Access Compliance Report

Public Rights-of-Way

(Curb Ramps)

Intersection ID: 28724	Main Street: NORTHWOODS_FOREST_DR	Cross Street: LAWING_SCHOOL_RD	Location: NE
ADA ID: 275B833BBD3A	Ramp Type: Perp	Initial Pass/Fail: Fail	Overall Compliance: No
Severity Score: 12.5			
Codes/Mitigation Info/Possible Solution		Field Measurements/Component Compliance

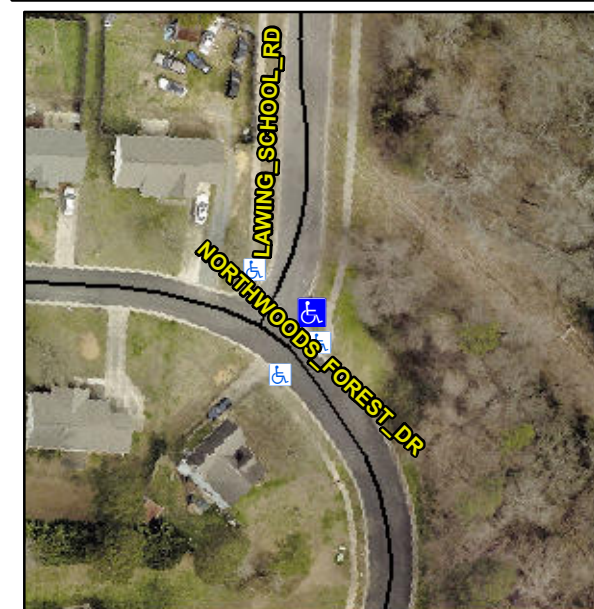
Compliance	Description	Data	Compliance	Description	Data
N/A	Ramp Length (in)	95.0	No	Ramp Slope (%)	8.5
Yes	Ramp Width (in)	49.0	Yes	Ramp XSlope (%)	0.3
N/A	Flare Type LT	N/A	N/A	Flare Type RT	N/A
N/A	Flare Slope LT (%)	N/A	N/A	Flare Slope RT (%)	N/A
N/A	Flare Traversable LT?	N/A	N/A	Flare Traversable RT?	N/A
N/A	Landing Length (in)	N/A	N/A	DWS Provided?	N/A
N/A	Landing Width (in)	N/A	N/A	DWS Contrast?	N/A
N/A	Landing Slope (%)	N/A	N/A	DWS Length (in)	N/A
N/A	Landing X Slope (%)	N/A	N/A	DWS Full Width?	N/A
N/A	Landing Curb? (Y/N)	N/A	N/A	DWS Offset (in)	N/A
N/A	Shared Landing?	N/A			
N/A	Gutter Ponding?	N/A	N/A	Gutter Slope (%)	N/A
N/A	Gutter Lip Ht (in)	N/A	N/A	Gutter X Slope (%)	N/A
N/A	Painted X Walk1?	No	N/A	Painted X Walk2?	N/A
	X Walk 1 Direction	To NW		X Walk 2 Direction	N/A
N/A	X Walk 1 Width (in)	N/A	N/A	X Walk 2 Width (in)	N/A
	X Walk 1 Slope (%)	2.7		X Walk 2 Slope (%)	N/A
	X Walk 1 X Slope (%)	0.8		X Walk 2 X Slope (%)	N/A

Remove & Replace Entire Ramp.
